RE: ZF FRIEDRICHSHAFEN AG, (“ZF”) SOFTWARE UPDATE CAMPAIGN
DUE TO CELL PHONE AND RADIO INTERFERENCE - ZF NHTSA 06E100

Safety Defect and Noncompliance Report Guide for Vehicles
PART 573 Defect and Noncompliance Report

Service Bulletin No. 308

No. 08_19

Figure 1. NO cellular phone decal.

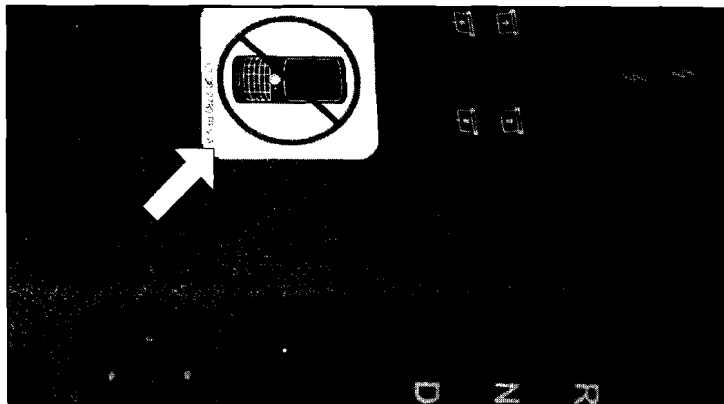
Qty.	New P/N	Description
1	07-08-2789	Decal, No Cell Phone

The only part required for this change is the 07-08-2789 Decal.
